**Project
T10/1683-D**

Revision 13
27 September 2007

**Information technology -
SCSI Architecture Model - 4 (SAM-4)**

Summary of Comments on SCSI Architecture Model - 4

Figure 1 — Requirements precedence

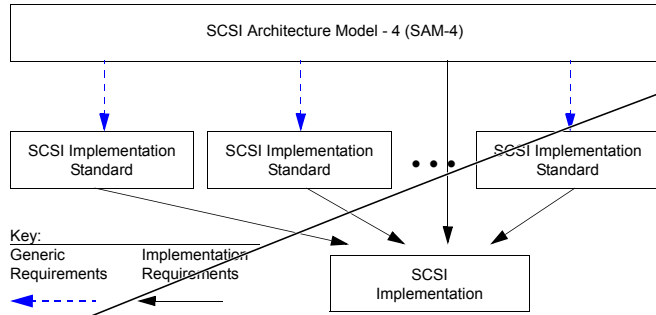
Author: Mark Evans, WDC Subject: Highlight Date: 10/25/2007 1:01:53 PM
 Since text takes precedence in this standard, and text should introduce figures, tables, etc., I recommend moving the following paragraph above figure 1.

Figure 2 — SCSI document structure

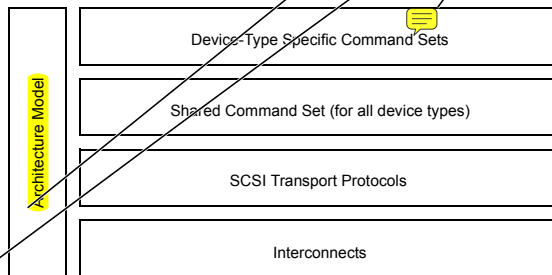
Status George Penokie Accepted 10/26/2007 2:31:33 PM
 Author: Mark Evans, WDC Subject: Note Date: 10/25/2007 1:03:15 PM
 I recommend that at least one "e.g." be added either in the four rows in figure 2, in the descriptive text that follows, or both. See SBC-3 for an example.

Status George Penokie Accepted 10/29/2007 3:50:40 PM
 Author: Emulex Subject: Highlight Date: 10/30/2007 1:16:34 PM
 Emulex-001
 Page: 2 first sentence below Figure 2 - "roadmap" s/b "document structure"

Status George Penokie Rejected 10/29/2007 4:06:27 PM
 Author: George Penokie Subject: Note Date: 10/26/2007 2:33:21 PM
 Copied the SBC-3 figure into SAM-4.

Figure 4 — Notation for association relationships for class diagrams

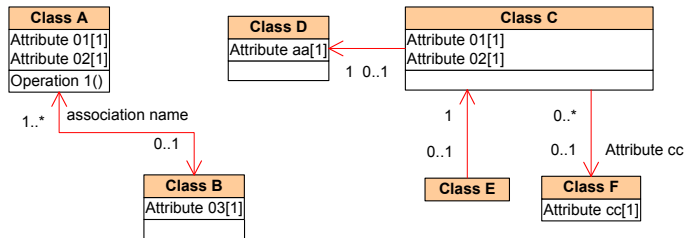
Author: Mark Evans, WDC Subject: Highlight Date: 10/29/2007 1:19:21 PM
 *Solid lines with arrowheads (see figure 4) are the notation...
 sfp
 "...is the notation..." ["notation" meaning, "...any particular system of characters or symbols used to briefly express elements...", and this is my first choice]
 or
 "...are the notations..." ["notations" meaning, "...the characters or symbols used in such a system...]
 One way or the other, the verb has to agree with the object (i.e., either "is the notation" or "are the notations").
 Status
 George Penokie Accepted 10/29/2007 10:25:26 AM
 Author: George Penokie Subject: Note Date: 10/29/2007 10:25:18 AM
 Changed to "is the notation"

Figure 5 — Notation for aggregation relationships for class diagrams

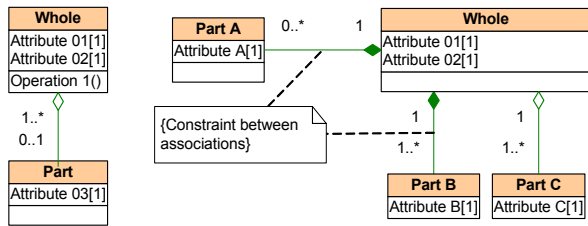
Author: Mark Evans, WDC Subject: Highlight Date: 10/29/2007 1:18:53 PM
*Solid lines with diamonds (see figure 5) are the notation...
s/b
*...is the notation... [see my earlier comment]
Status
George Penokie Accepted 10/29/2007 10:26:15 AM

Figure 12 — SCSI client-server model

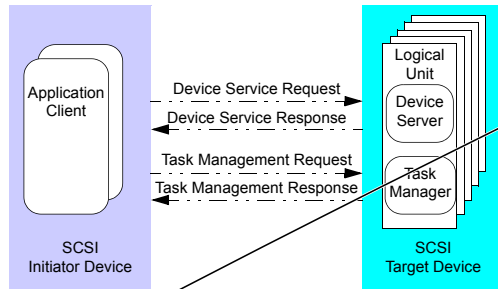
- Author: relliott Subject: Note Date: 10/28/2007 10:37:45 PM
The last paragraph in 4.3.1 discusses commands and device server requests. It should also discuss TMFs and task management requests, to cover everything shown in figure 12.

Figure 19 — SCSI Initiator Device class diagram

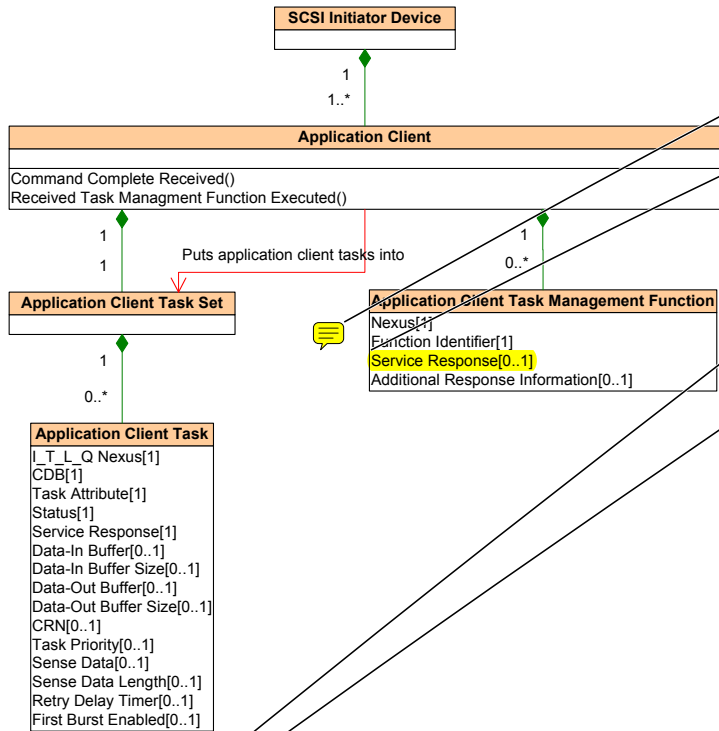
Author: reilott Subject: Note Date: 10/8/2007 6:53:04 PM
 Nexus and Function Identifier should be swapped in figure 19 and in sections 4.5.11.2 and 4.5.11.3 to match the SCSI Target Device side in figure 22 and following sections. (or the target side should be swapped to follow this)

Figure 22 — Logical Unit class diagram

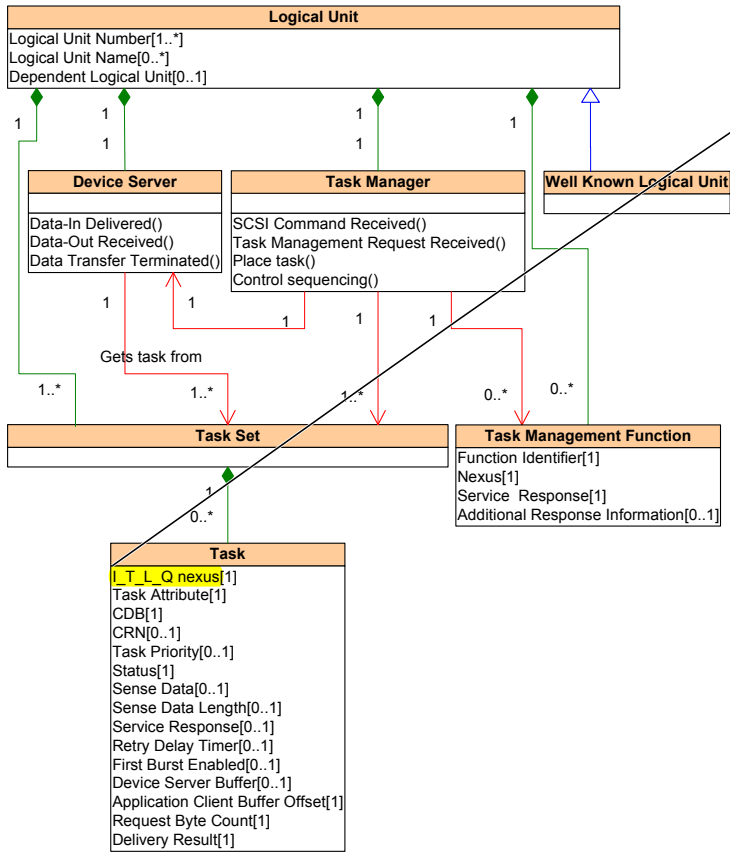
There is no class with that name, and it doesn't appear in figure 22.

Author: relliott Subject: Highlight Date: 10/8/2007 6:46:29 PM
4.5.24.3 should be swapped with 4.5.24.2 to match the order the attributes are listed in figure 22.

Figure 30 — SCSI target device and SCSI initiator device configured in a single SCSI domain

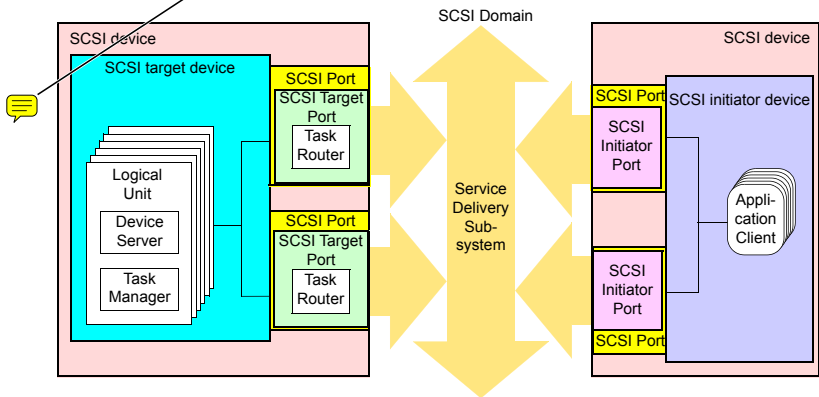
Author: Mark Evans, WDC Subject: Highlight Date: 10/25/2007 11:10:07 AM
 *This standard does not require a SCSI target device to have the ability to detect the presence of a SCSI initiator device with multiple SCSI initiator ports. Therefore, a SCSI target device handles a SCSI initiator device with multiple SCSI initiator ports exactly as it would handle multiple separate SCSI initiator devices (e.g., a SCSI target device handles the configurations shown in figure 29 and figure 30 in exactly the same way it handles the configuration shown in figure 28).
 s/b
 *This standard does not require a SCSI target device to be able to detect that a SCSI initiator device contains more than one SCSI initiator port. In the cases where a SCSI target device does not detect that a SCSI initiator device contains more than one SCSI initiator port, the SCSI target device interacts with the SCSI initiator device as if each SCSI initiator port was contained in a separate SCSI initiator device (e.g., a SCSI target device operates in the configurations shown in figure 29 and figure 30 in the same way it operates in the configuration shown in figure 28).

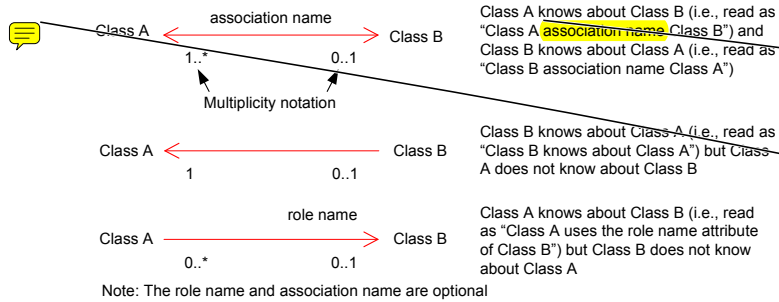
Author: relliott Subject: Note Date: 3/12/2008 9:38:56 AM
 As proposed in 08-113r1 for SPC-4, add a figure right here showing constraints and notes.
 Status: George Penokie Accepted 3/26/2008 8:42:24 AM

Figure 4 — Notation for association relationships for class diagrams

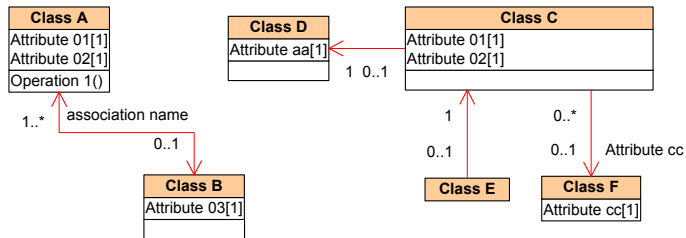
"is" is very awkward given that all the nouns on the left are plural.
Restructure as
*The notation used to describe the association relationship between classes in class diagrams is solid lines with arrowheads (see figure 4).
Apply to all the figure introductions in this section.
